28 June 2019

Alison Johnstone
Silver Fern Farms Ltd
RD2 Fairton
PO Box 30
ASHBURTON 7740

SILVER FERN FARMS TAKAPAU CONSENT RENEWALS SECTION 92 REQUEST

Figure 1: Run 15, Block D soil moisture content (2015-2016)

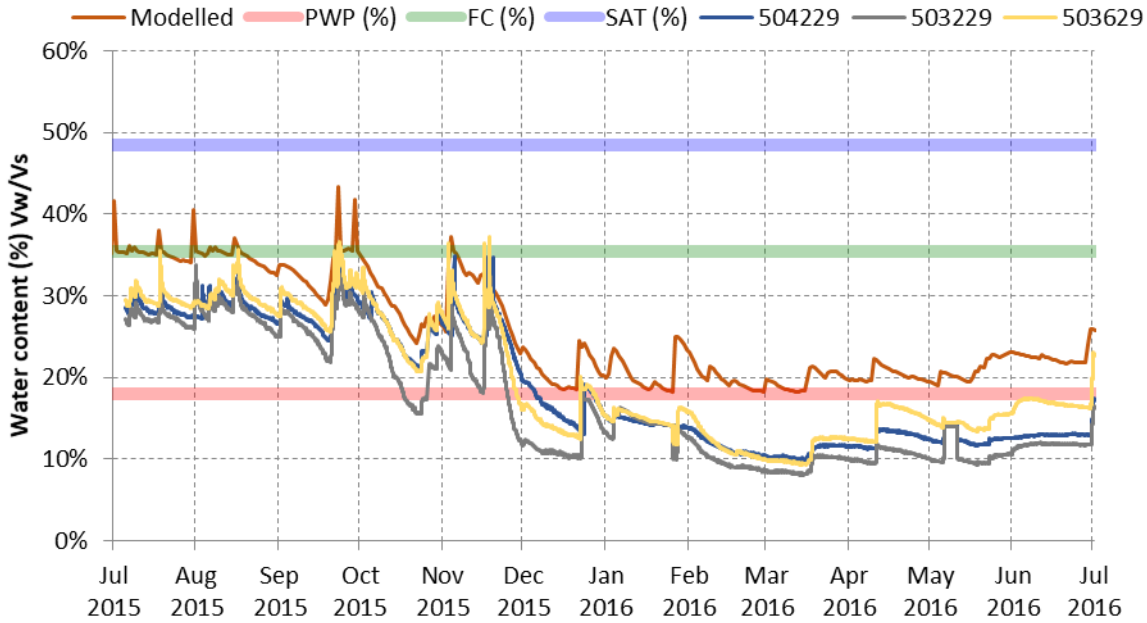
14. Provide an analysis of the available soil moisture data for the irrigation blocks (collated using daily medians) to demonstrate how condition 42 of the existing consent has been complied with (i.e. irrigation not causing an exceedance of field capacity). Identify all key parameters including field capacity, wilting point, and irrigation decision points, and explain how the soil moisture system is used in scheduling and irrigation decision making.

Figure 1 shows an example of the modelled soil moisture content for Run 15 in Block D against the telemetered soil moisture data collected from the three sensors located in the run area. The run area was modelled as Takapau soil planted with grass pasture and an assumed rooting depth of 0.60 m. The modelled soil moisture content follows the trends of the measured soil moisture content closely but does drop as low as the measured data. This offset is expected to be caused by slight differences in the soil

Figure 4: Border Dyke area 1-10, soil moisture content during wet season (2013 – 2014)

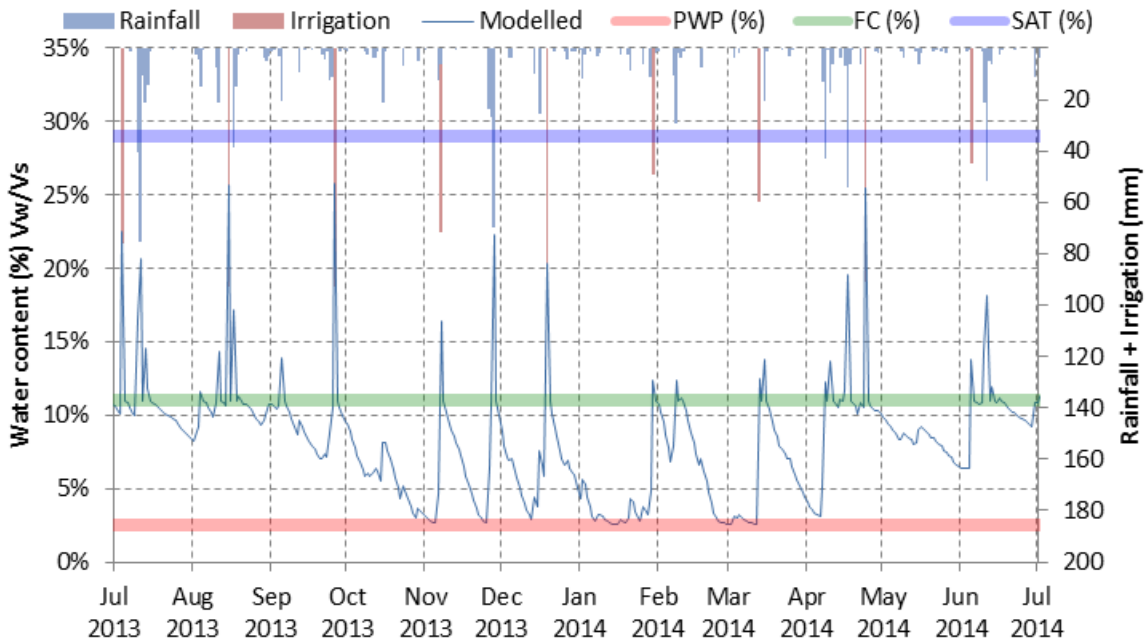
22. Supply a soil moisture water budget calculation for the worst-case wet conditions and dry conditions, to provide context on the ability of the soil to store water and reduce excess percolation to groundwater. The calculation should define all parameter values and assumptions, such as soil depth, average porosity, soil moisture capacity, unsaturated and saturated infiltration rates, and unsaturated and saturated sub-soil drainage rates.

The modelled soil moisture results for one of the two border-dyke irrigation blocks which receive irrigation alternately are shown for the worst case wet and dry seasons in the model period in Figure 4 and Figure 5, respectively.

The results illustrate how the irrigation is applied consistently (in large doses in accordance with the consent) to an individual area every 42 days. This method of application means the irrigation applications always cause the soil to exceed field capacity, even during a dry year, which results in drainage to groundwater. The large return interval also means that the soil is also expected to dry out to permanent wilting point (PWP) in between irrigation events, which inhibits grass growth and reduces the amount of actual evapotranspiration (ET) from the soil, as water becomes harder for plant roots to extract from the soil.

During the 2013-2014 wet year, average irrigation was approximately 630 mm, annual rainfall was 1,020 mm and actual ET was calculated to be approximately 720 mm (compared to PET of 994 mm). During this year, drainage was approximately 930 mm. During the 2008-2009 dry year, average irrigation was approximately 640 mm, annual rainfall was 430 mm and actual ET was calculated to be approximately 600 mm (compared to PET of 930 mm). During this year, drainage was approximately 460 mm.

FIGURE 1 : Bore Locations and Ground Surface Elevation

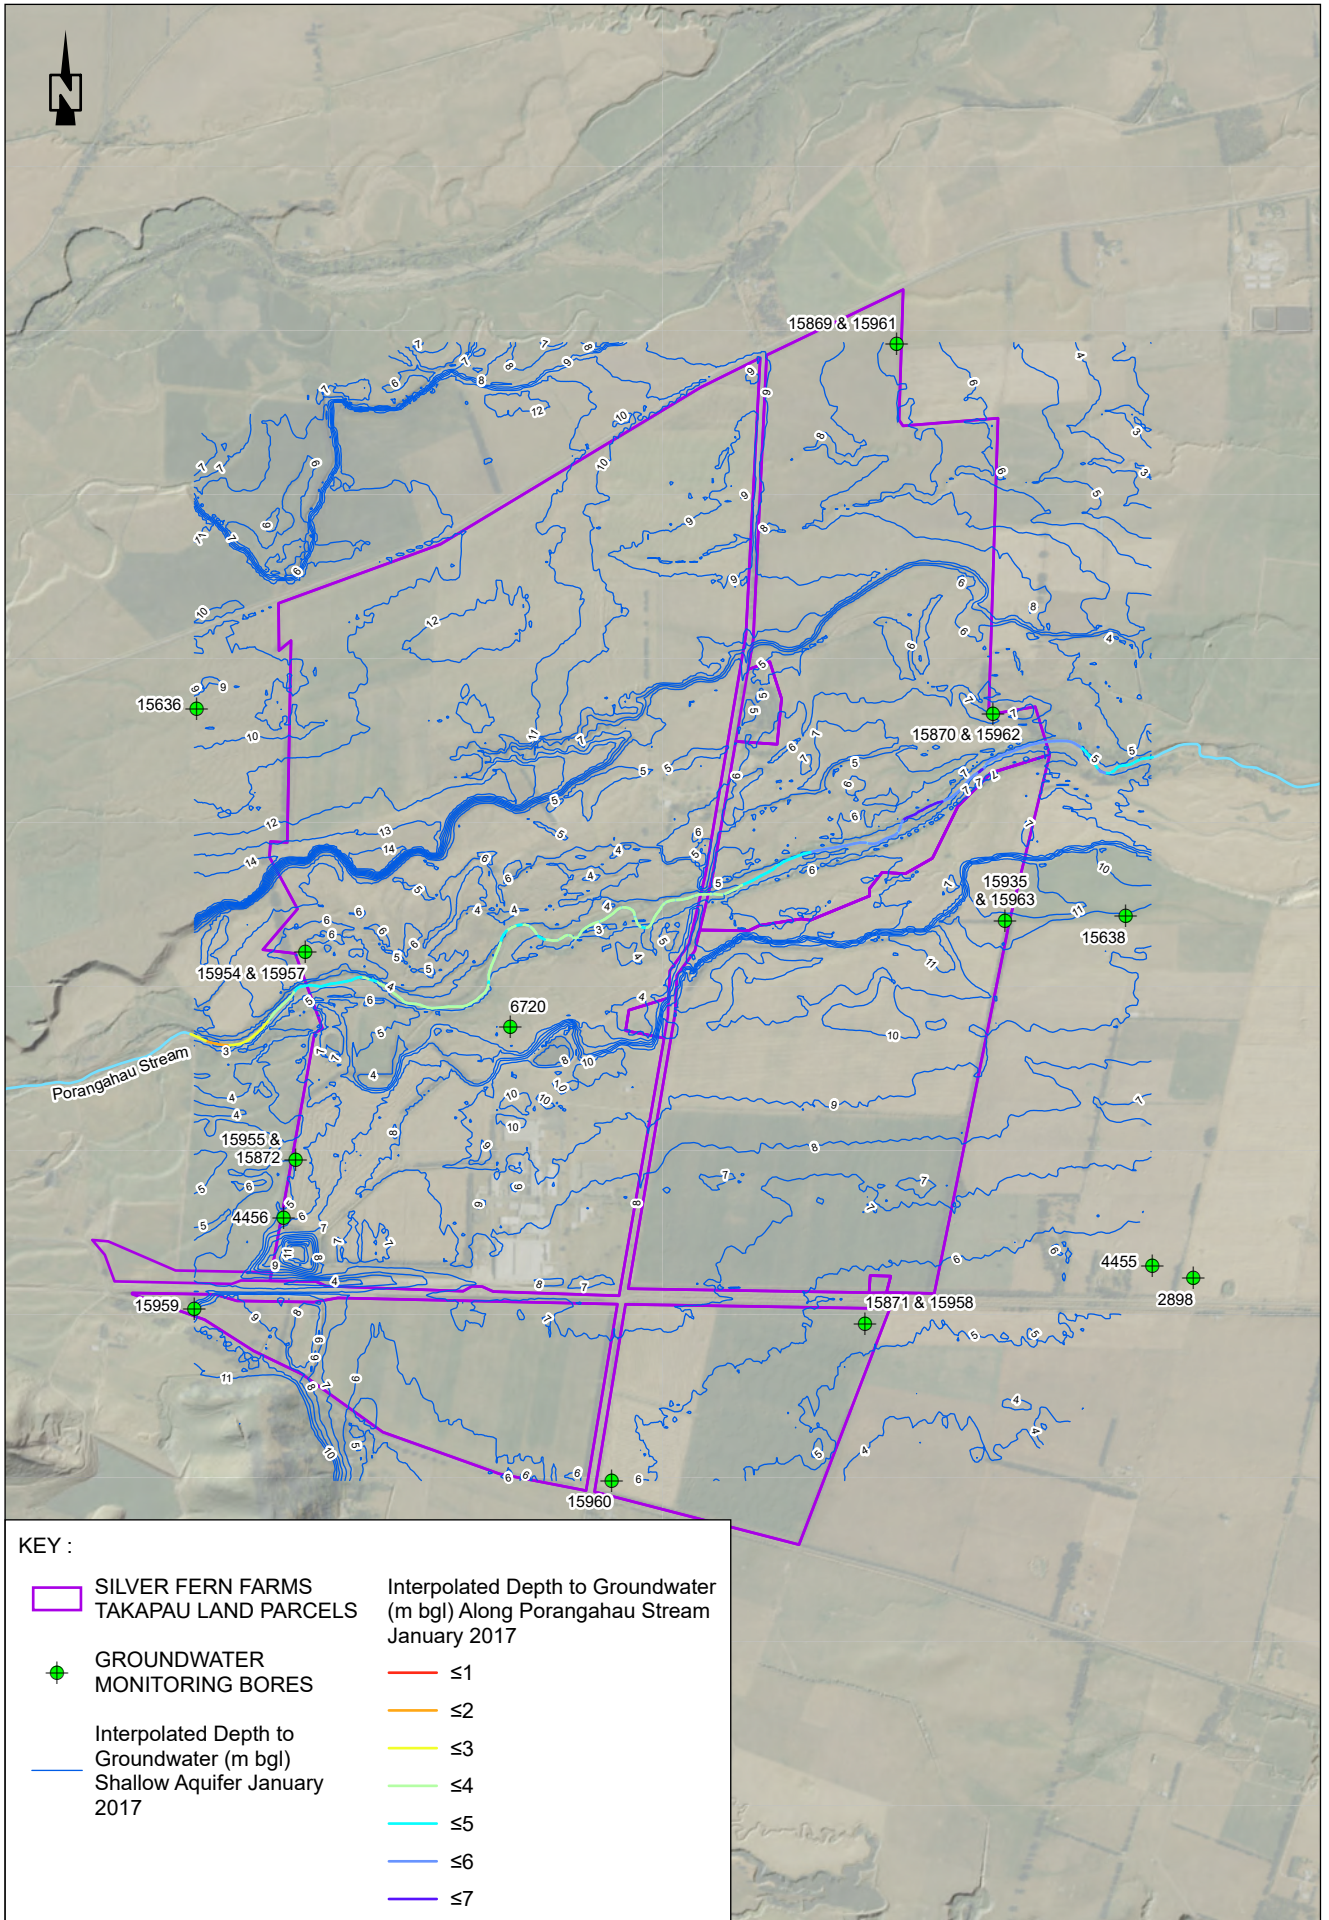
6. A map showing all monitoring bores (shallow and deep) and interpolated depth to groundwater contours in metres below ground level (mBGL) across the site and immediate surrounds (0.5 km buffer).

Figure 1, appended, shows the Silver Fern Farms monitoring bore locations together with groundwater surface elevation contours obtained from LiDAR data, in metres above sea level (m amsl). The LiDAR data used was HBRC's 250 mm contours from the Central Hawke's Bay (2006 May) ID#11 Survey. The data was first translated from the vertical datum used for all HBRC Engineering data (MSL = 10 m) to metres above sea level. Also shown on Figure 1 is the LiDAR elevation along the length of the Porangahau Stream. This will reflect either the elevation of the stream surface or the land directly adjacent to the stream.
